Proposal for Supplement 1 to the Regulation on Pole Side Impact in its original version

Proposal for Supplement 1 to the 01 series of amendments to the Regulation on Pole Side Impact

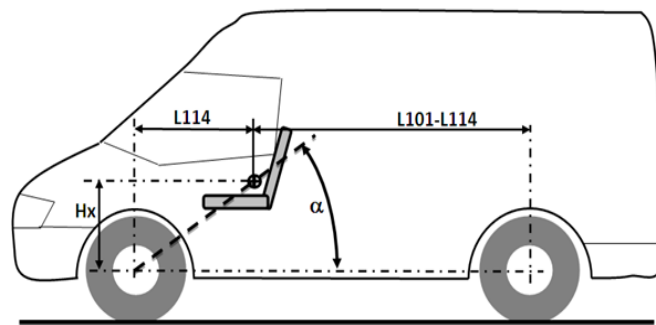
Paragraph 1.1., amend to read:

"1.1. This Regulation applies to:

- (a) Category M₁ vehicles **with a gross vehicle mass of up to 3500 kg;**
and
- (b) Category N₁ vehicles where the angle alpha (α), measured rearward from a **horizontal plane passing through the centre of the front axle to an angular plane passing through the centre of the front axle and the R-point of the driver's seat** is less than 22.0 degrees; or the ratio between the distance from the driver's R-point to the centre of the rear axle (L101-L114) and the centre of the front axle and the driver's R-point (L114) is less than 1.30.²

4. Paragraph 1.1.(b) was slightly amended to further clarify the determination of N1 vehicles in the scope.
